Service Bulletin

Subject: RATTLE NOISE FROM BOTTOM OF A-PILLAR	Bulletin No: 09-001/14
	Last Issued: 01/08/2014

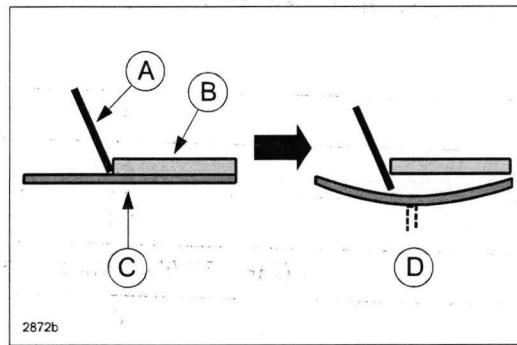
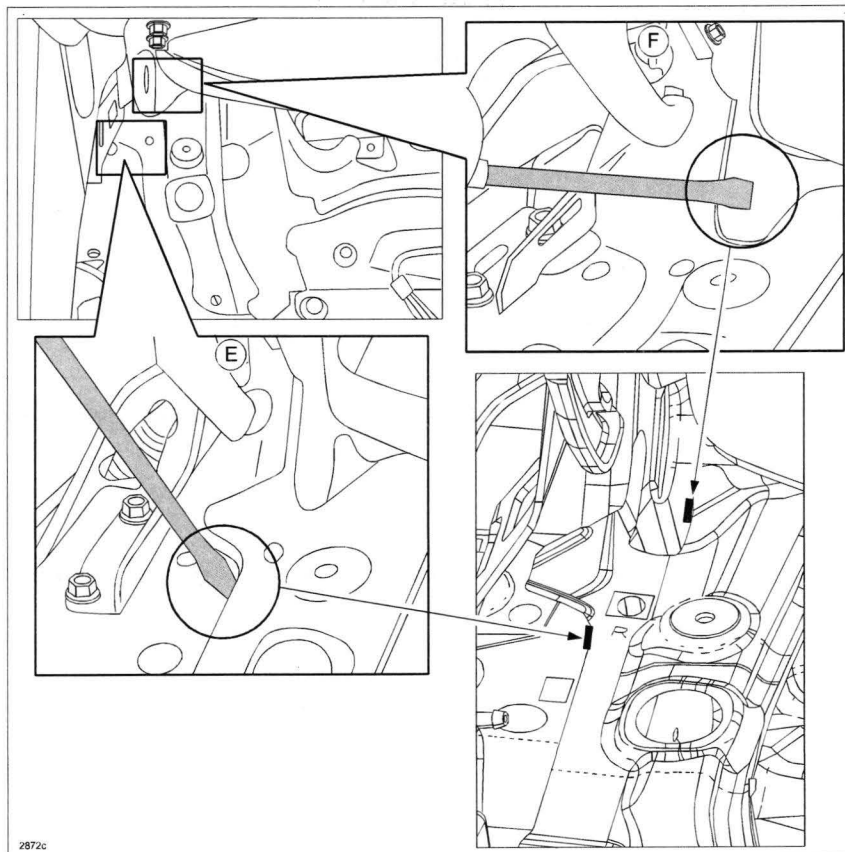
Some vehicles may exhibit a rattle noise from the bottom of the A-pillar when driving on rough roads or over bumps. This is caused by the cowl upper plate and/or dash upper panel interfering with the wiper bracket. To correct the problem, the shape of the wiper bracket has been changed. For the affected vehicles, a clearance needs to be created between the wiper bracket and cowl upper plate and between the wiper bracket and dash upper panel.

3. Place the tip of a covered* flat-blade screwdriver (A) between the two panels (B and C) at the joint (between the wiper bracket and cowl upper plate (E) and between the wiper bracket and dash upper panel (F)) and hit the head of the screwdriver with a hammer to create a clearance of approximately 0.5 mm (D) between the two panels.

***NOTE:** To avoid damage to the paint, wrap protective tape around the tip of the screwdriver. If the panels are scratched, apply appropriate corrosion protection primer.
